STATUS CHECK	Commercial Building Permit	Application # 13-128268-REV-01-CO
Status Date: August 01, 2013		IVR Number: 3347854

PROJECT INFORMATION	Description of Work: REVISION-CHANGE DOOR LOCATION FROM BOTTOM OF MEZZANINE STAIR TO LANDING AT TOP OF STAIR PER APPEAL
Street 424 SW 4TH AVE	
Address

13-128 268 REV01 CO
Witherspoon Building
Tenant Improvements
424 SW 4th Ave
Portland, OR 97204

MEZZANINE
FLOOR PLAN

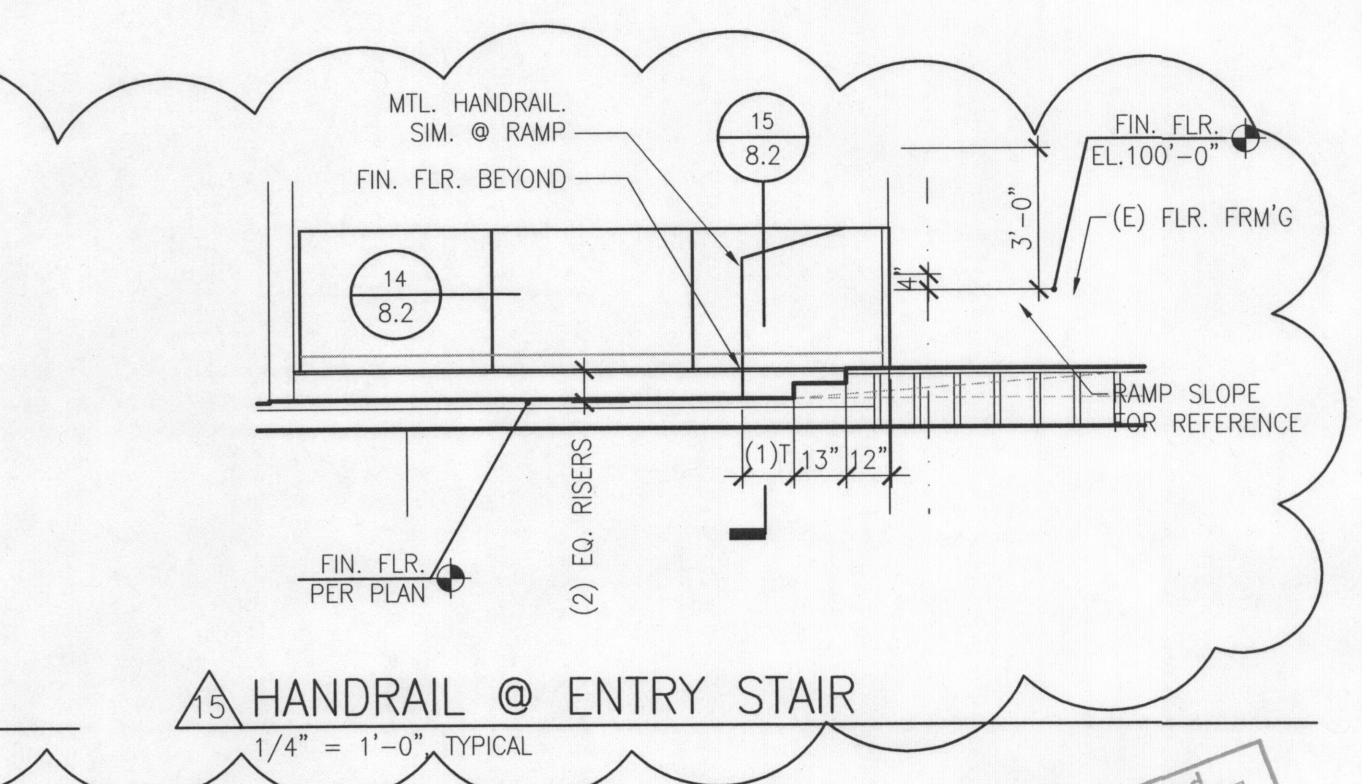
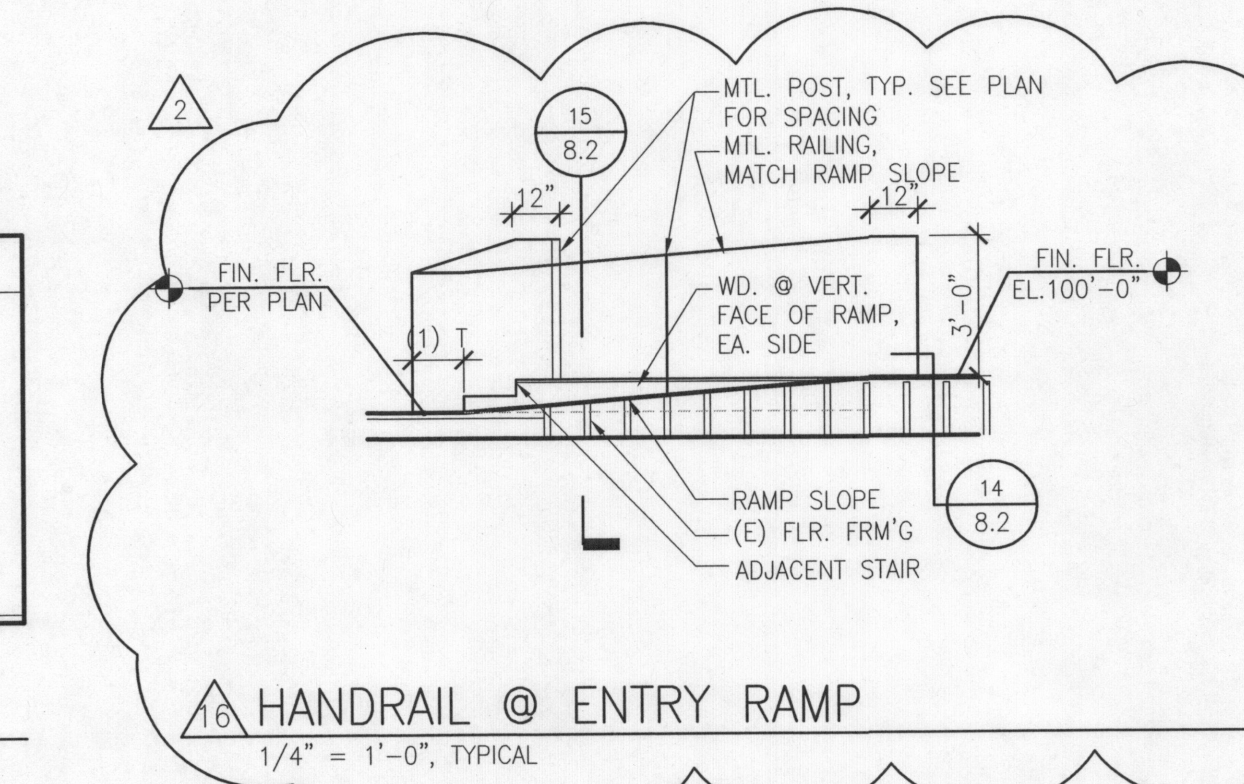
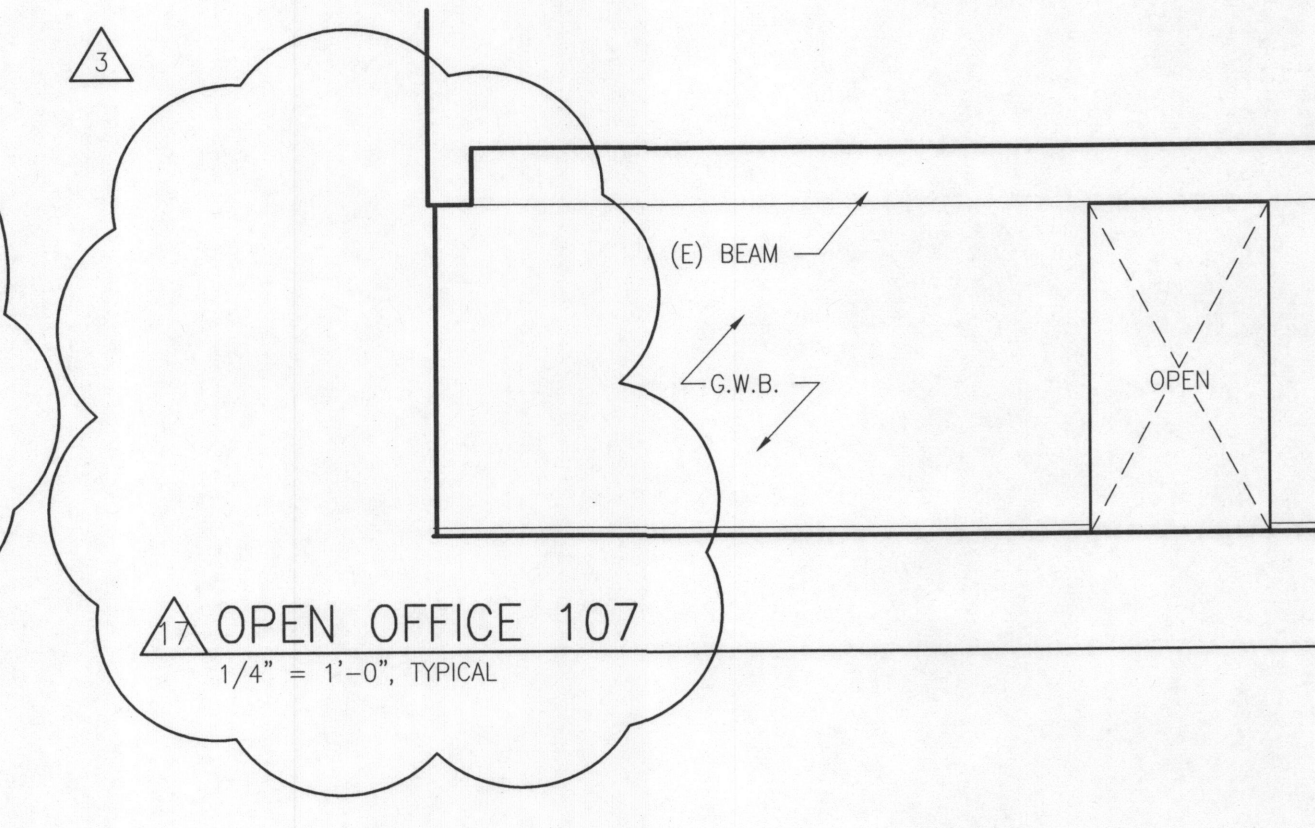
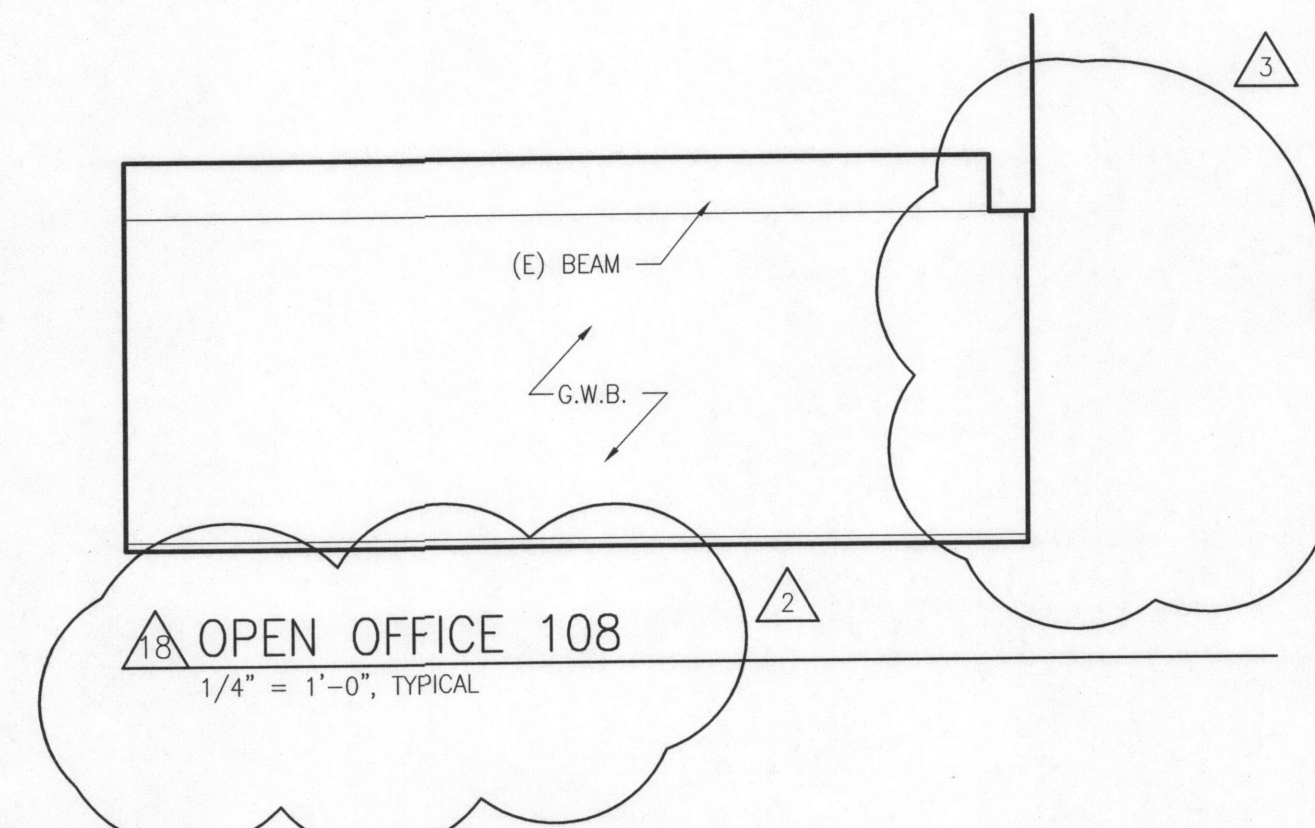
DOOR LOCATION CHANGE FROM BOTTOM OF MEZZANINE
STAIR TO LANDING AT TOP OF STAIR.
